September 18, 2008

Mr. Kyrik Rombough South Dakota Department of Environment and Natural Resources Air Quality Division 523 East Capitol Pierre, SD 57501

Subject: Basin Electric Power Cooperative NextGen Project
Response to Comments on Air Quality Permit Application,
Monitored Data, and Modeling Protocols

# Basin NextGen BAM (PM 2.5)

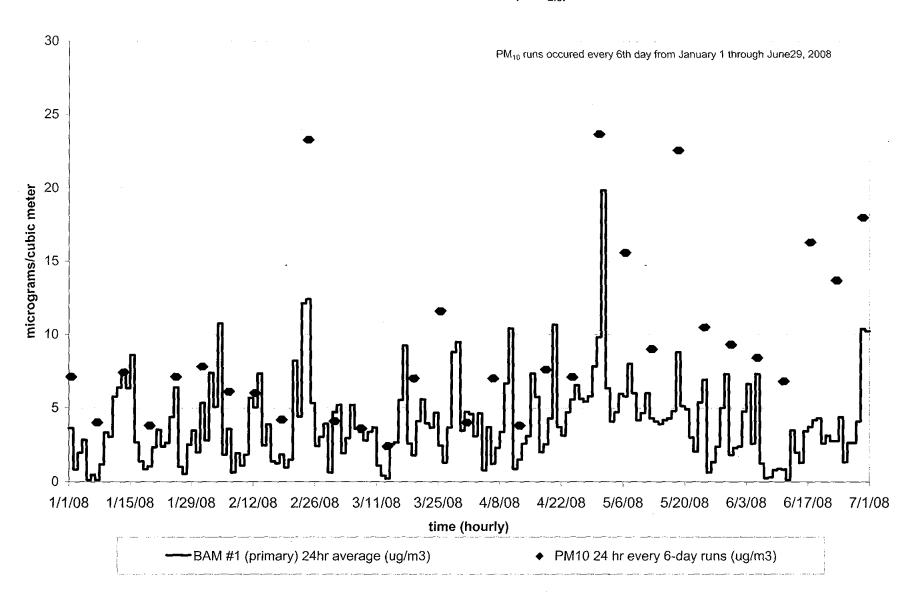
(4) SDDENR requested that we provide a separate summary of the PM<sub>2.5</sub> data for the period prior to the installation of this reference cyclone and after the installation of this unit. Attachment 1 provides a monthly summary and a daily time series of the 24-hour readings of the PM<sub>2.5</sub> primary sampler, along with a concurrent depiction of the six-day PM<sub>10</sub> 24-hour samples that were collected during the same time period.

The results show a consistent pattern of readings, with monitored levels slightly higher before September 28, 2007. The overall average for the first three months was  $11.3 \, \mu g/m^3$ , and the highest 24-hour average during that same time period was  $25.2 \, \mu g/m^3$ . The overall average during the period October 2007 through June 2008 was  $3.9 \, \mu g/m^3$ , or about one-third of the average for the earlier period. The highest 24-hour PM<sub>2.5</sub> reading was 22.0  $\, \mu g/m^3$  during that same 9-month period. As a result of this comparison, we expect the pre-September 28 data to be a conservative estimate of the levels that would have been monitored with the FEM cyclone head.
